INVITATION FOR BID (IFB) No. PAG-CIP-024-002 WELDER SHOP UPGRADES AND REPAIRS PROJECT

AMENDMENT No. 2 Date: August 29, 2024

Amendment to IFB 024-002. This Amendment No. 2 is hereby issued and revises and changes the original Scope of Work issued in the original IFB packet. Please refer to the New Scope of Work attached to this Amendment No. 2.

Welding Shop Building Repair

Figure 3: Exhaust Vent to be Removed and Replaced

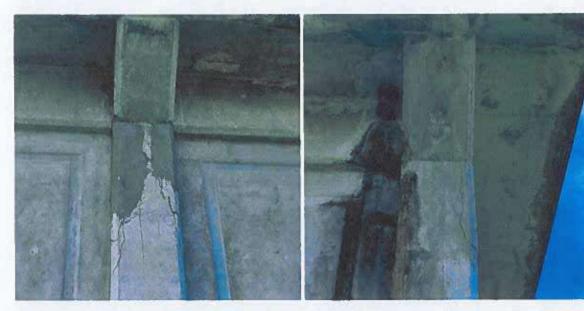
- a. Removal and refurbish existing exhaust vent.
 - b. Apply two (2) coats of epoxy coating to the refurbished exhaust vent. Color to be coordinated with PAG.

- c. Any repair work required to re-install the exhaust vent is included in the scope of work.
 - d. Contractor to retrofit a cover to close the vent during storm conditions.

Figure 11:Downspout Location (West)

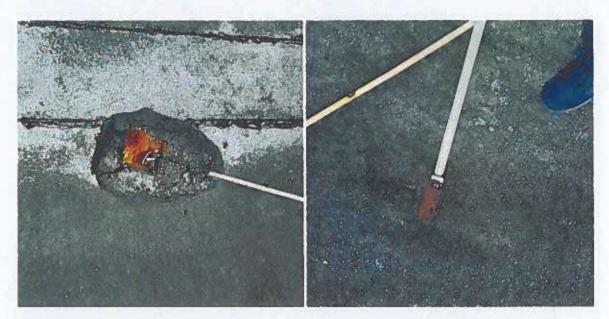
- j. Repaired concrete must be given time to cure prior to final inspection by PAG.
- 2. Remove and Replace Existing Roof Drain and Down Spout
 - a. Remove existing roof drain.

- b. Remove existing down spout and mounting hardware.
 - c. Supply and install new 6" roof drain.
 - d. Supply and install new down spout and mounting hardware.

Figure 17: Welding Shop Roof Top

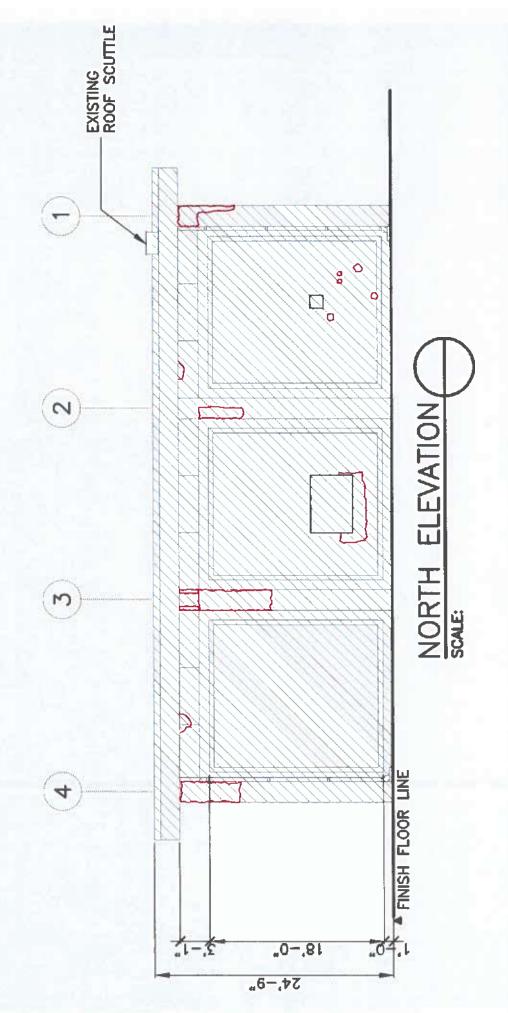
- c. The Contractor must seal all construction joints located on the roof top of the welding shop prior to applying any paint.
- d. In general, sealing the joint includes, removing any existing joint material protruding from the roof, applying sealant, fabric reinforcement, and a second coat of sealant. See attached detail for construction joint.

Figure 20: Light Fixture and Condult to be Replaced

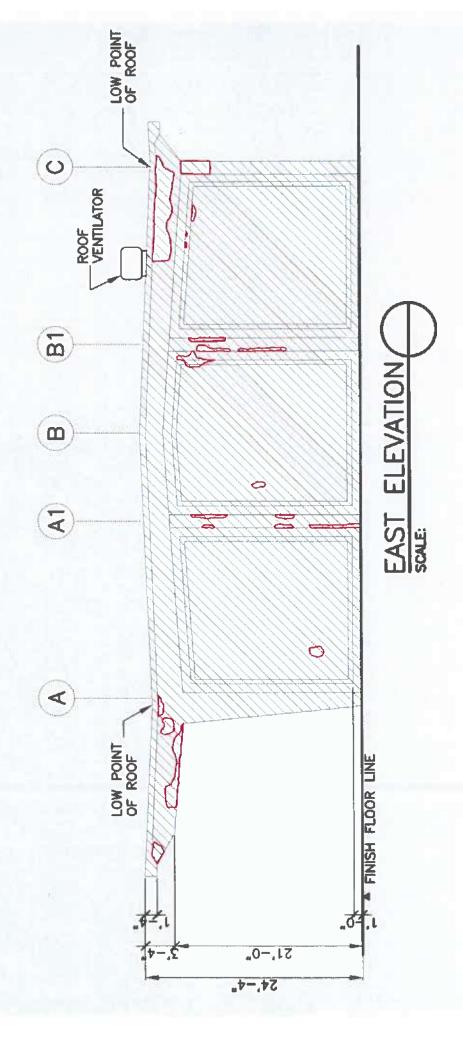
- d. Concrete must be repaired.
- 9. Replacement of Electrical Pendant Light
 - Removal and disposal of existing lights and light fixtures. Must be disposed of at a GEPA approved facility.

- b. PAG Facility maintenance will inspect lights that have been removed and determine if they can be kept as spares.
- c. Supply of LED equivalent light fixture. Must be suitable for marine environments.
- d. Installation of LED equivalent light fixture.
- e. Removal of corroded electrical conduit and lines. (Est. 260 ft)
- f. Supply and install new electrical conduit and lines.
- g. Must be inspected and certified by a registered master electrician.
- h. As-Built Drawings/Plans Required.
- i. Contractor must provide a submittal for all materials utilized. All materials utilized must be approved by the PAG Engineering Division.
